Development Review Committee (DRC) Meeting

1. CALL TO ORDER
2. ROLL CALL
3. APPROVAL OF MINUTES
 - DRC meeting on May 21st, 2024
4. NEW BUSINESS
 - **Case # 23-01-ODP-Highbanks Townhomes; Second Review**, Applicant is requesting approval of an Overall Development Plan for a residential development in the Glen Abbey PUD on East Highbanks Road, consisting of 126 townhomes, located on the properties with the Volusia County parcel IDs 802600000065 and 802700000062.
5. ADDITIONAL BUSINESS:
6. DISCUSSION:
7. ADJOURNMENT:

The applicant is requesting approval of an Overall Development Plan for 126 Townhome units off of East Highbanks Road located on the parcels with the Volusia County IDs 802600000065 and 802700000062.

OVERALL DEVELOPMENT PLANS FOR Highbanks Townhomes

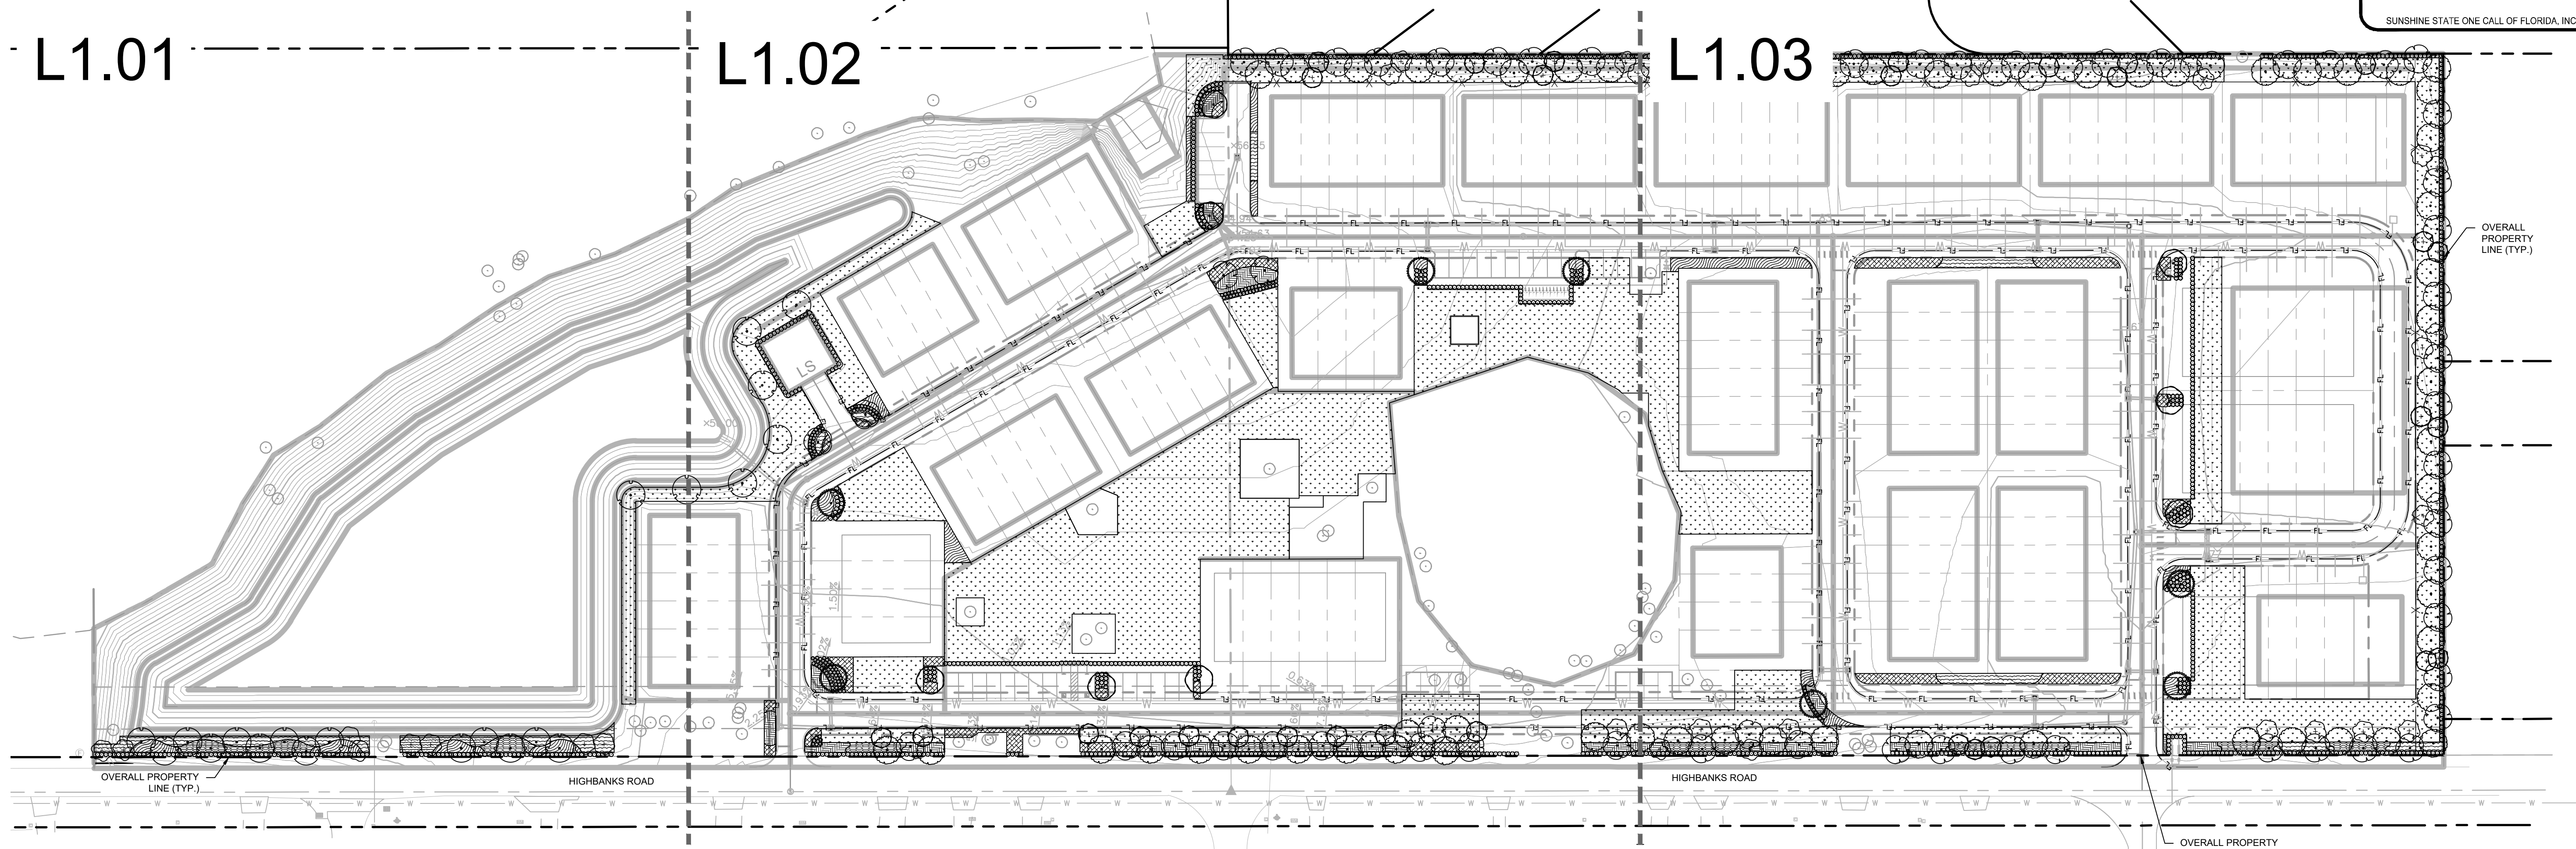
Please provide a note on Sheet L1.00 stating all landscape areas shall be designed with plant spacing to achieve coverage of 80% of the landscape areas with living organic plant materials within 2 years.

SHEET NUMBER
L1.02

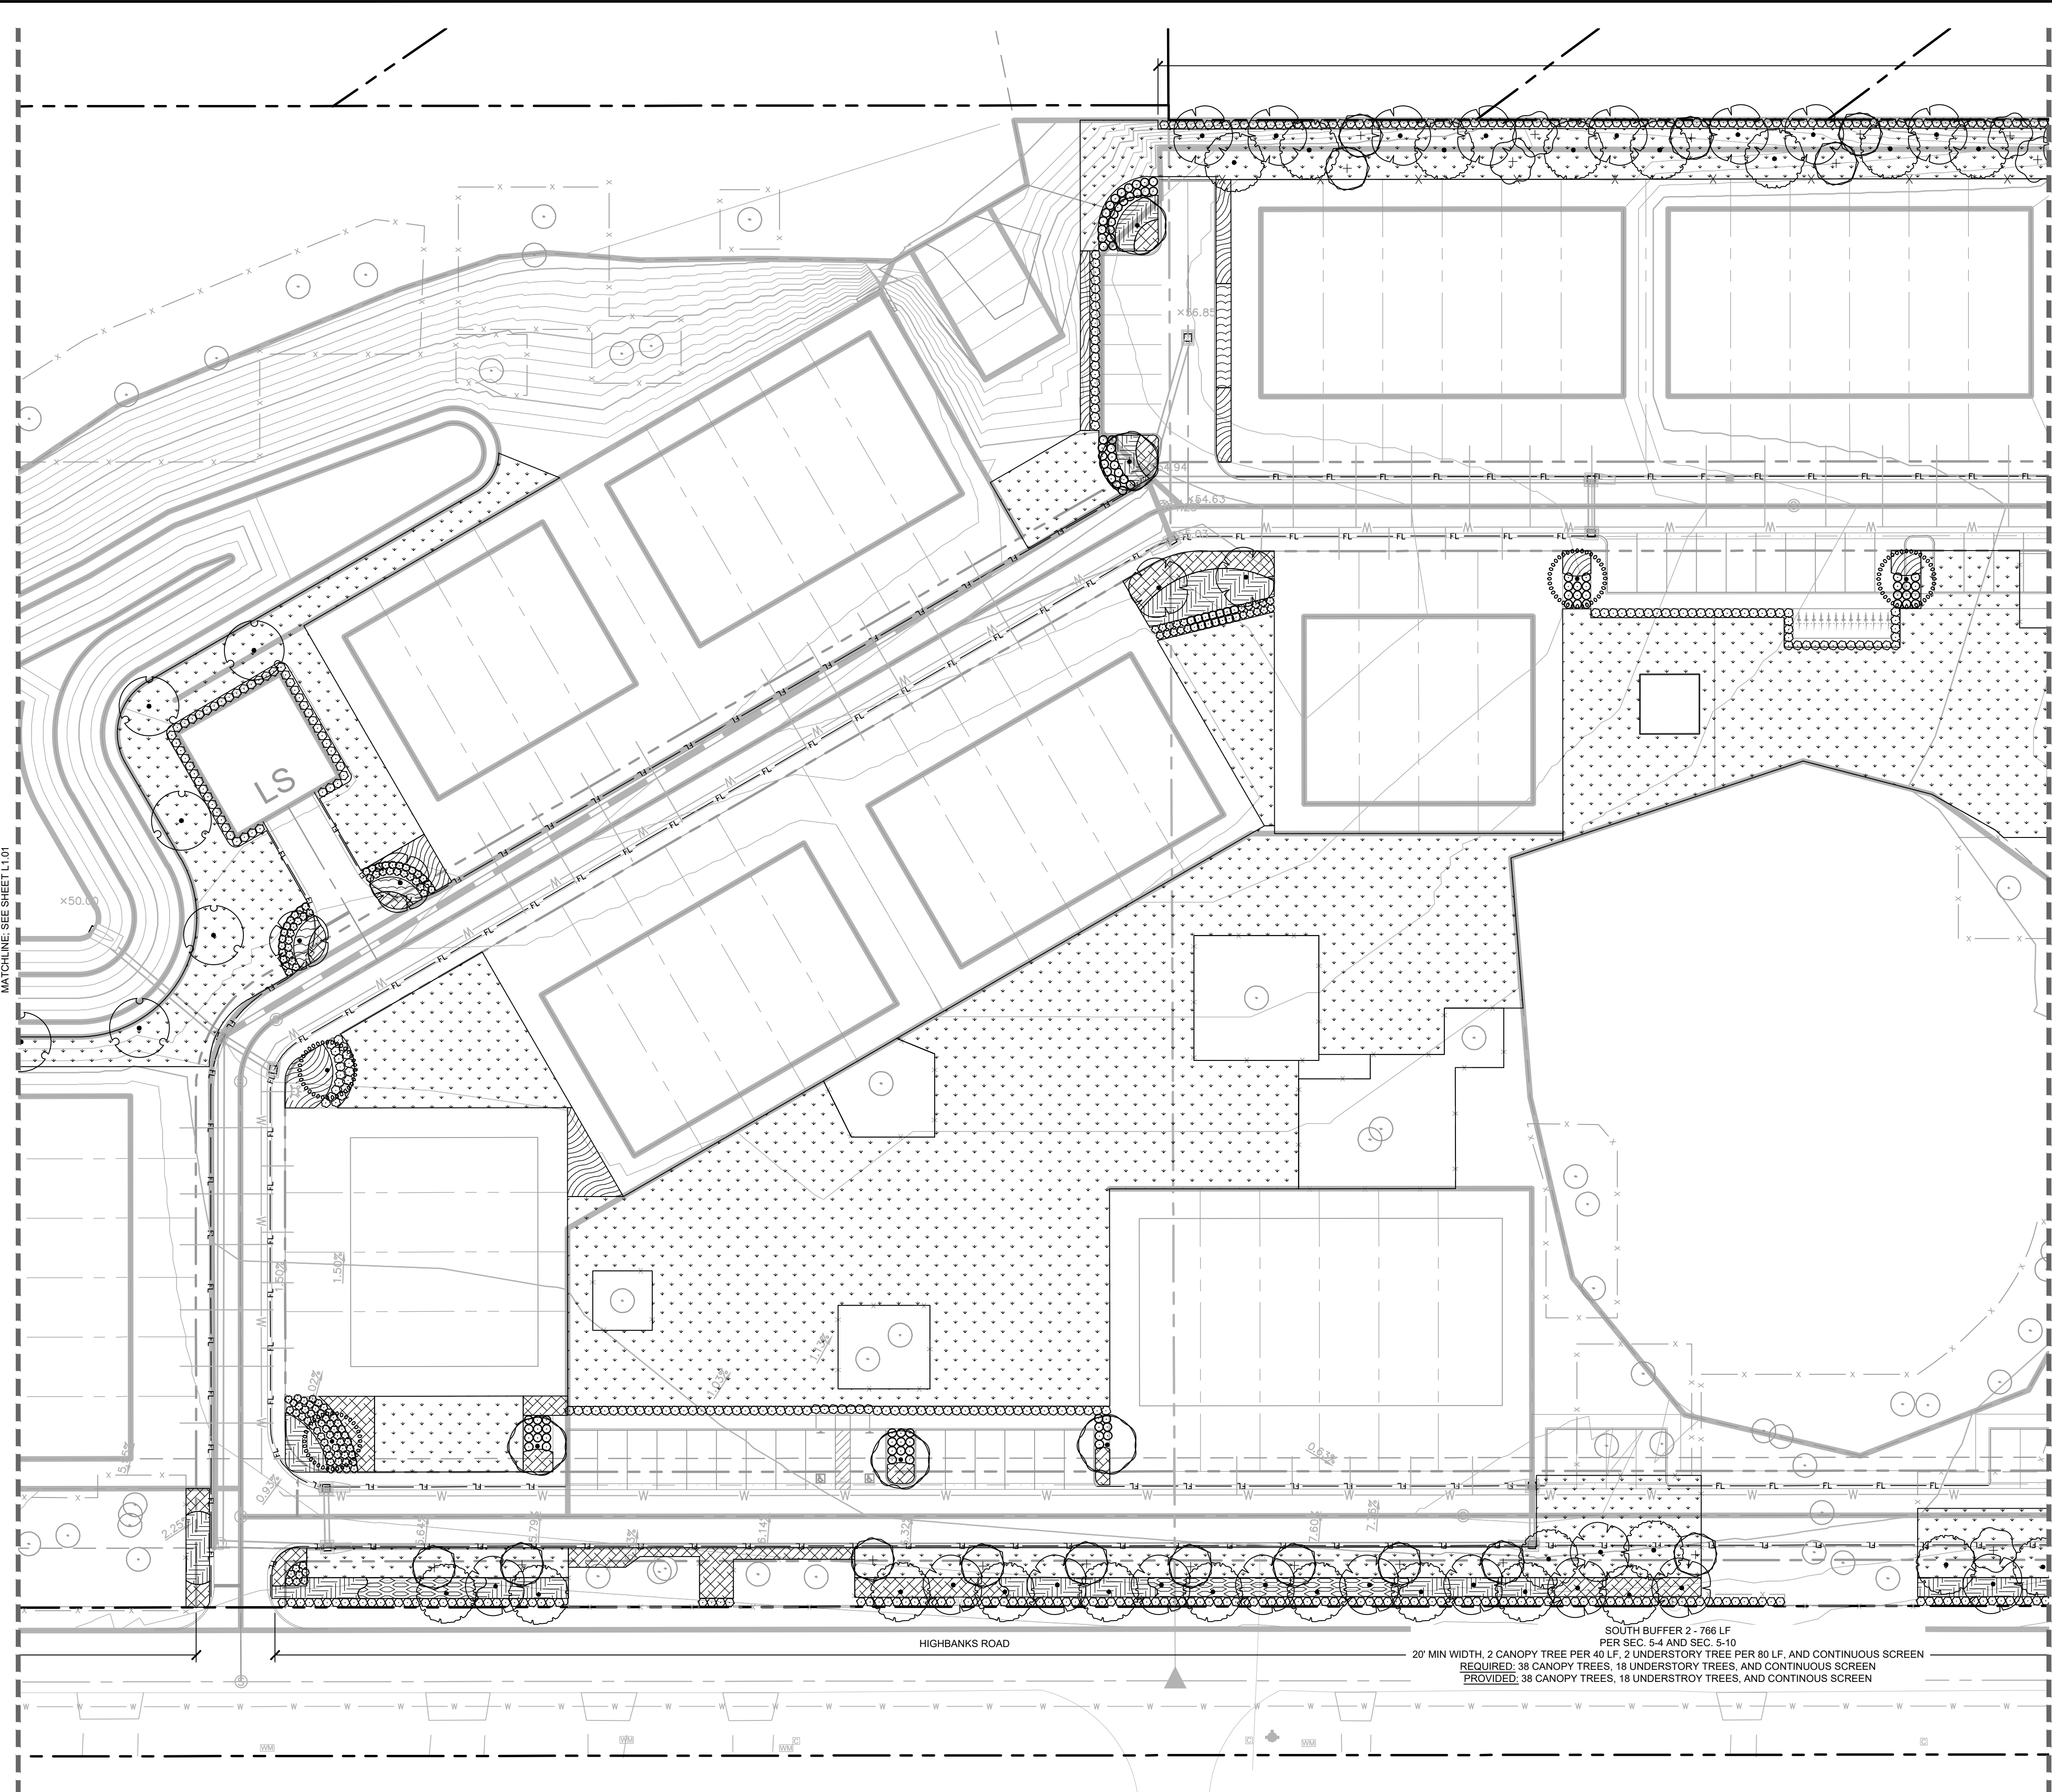
Section 5-4 provides for the provision of buffer yards and screening. **On Sheet L1.03, there is an area in the northern landscape buffer lacking landscaping. On Sheet L1.02, there is an area in the southern landscape buffer lacking landscaping. Please provide clarification.**

SHEET NUMBER
L2.01

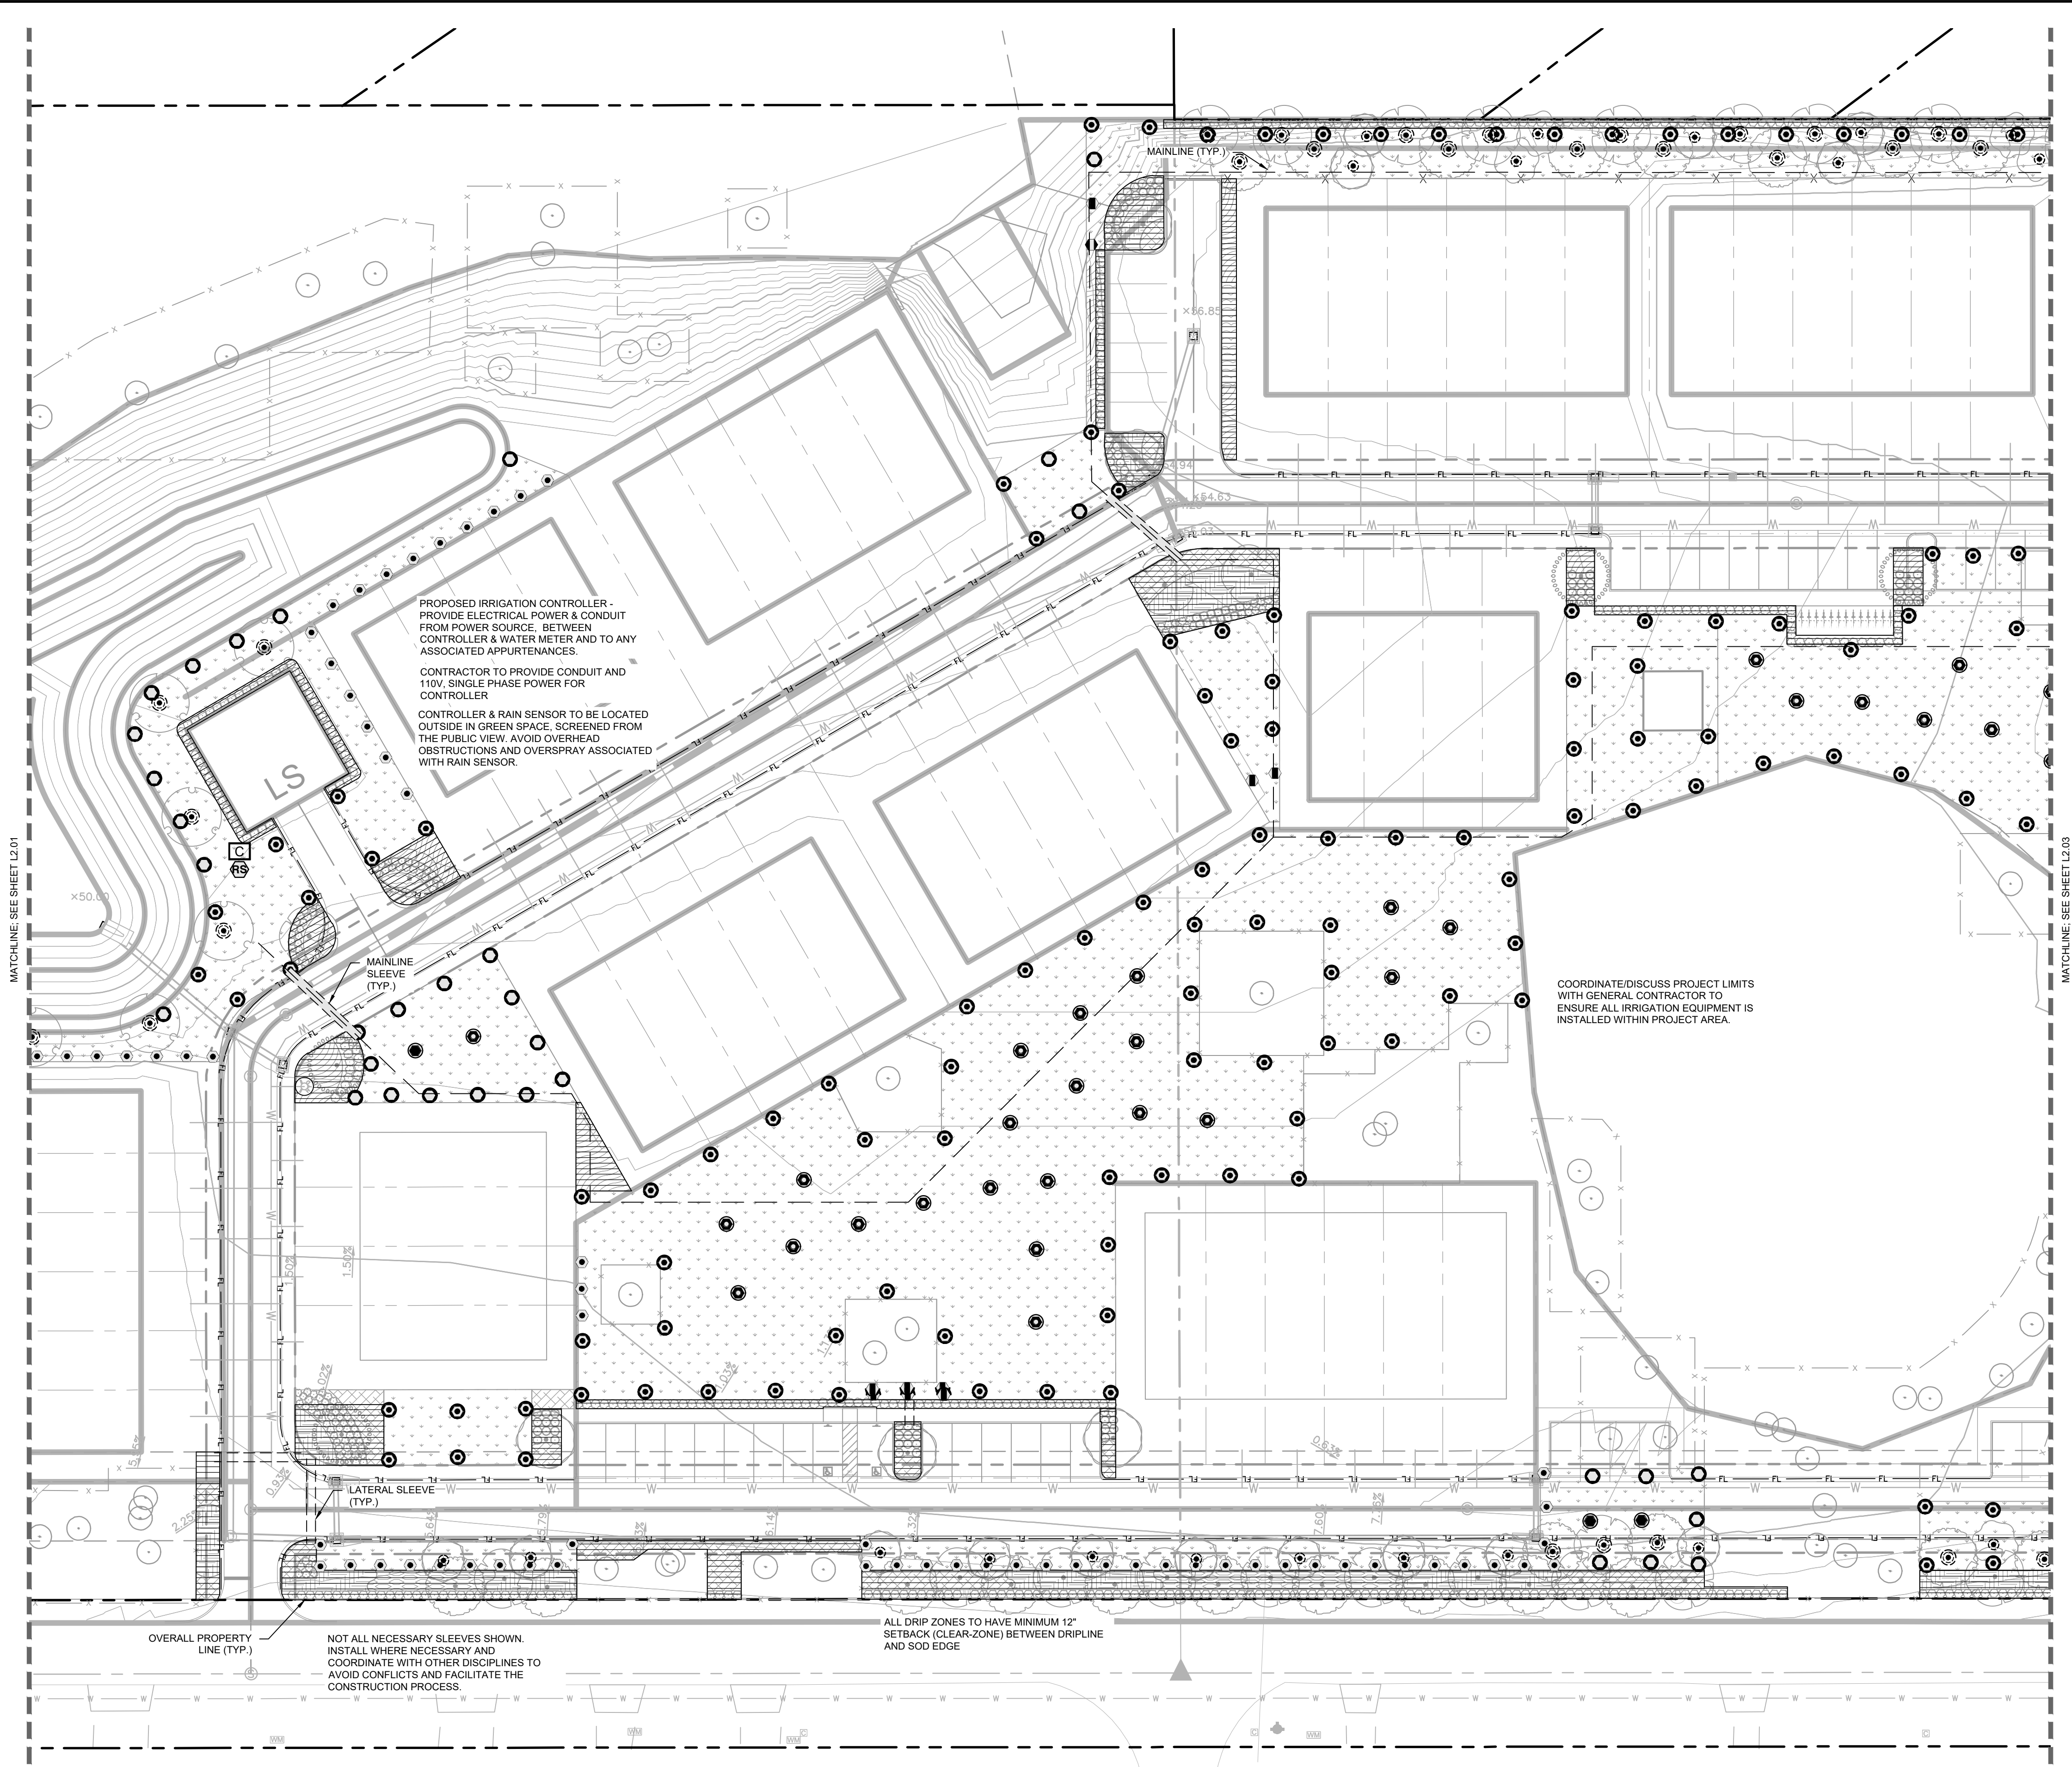
Section 5-12 provides for irrigation requirements. **On Sheet L2.01, the landscaping fronting East Highbanks Road does not appear to have irrigation.**
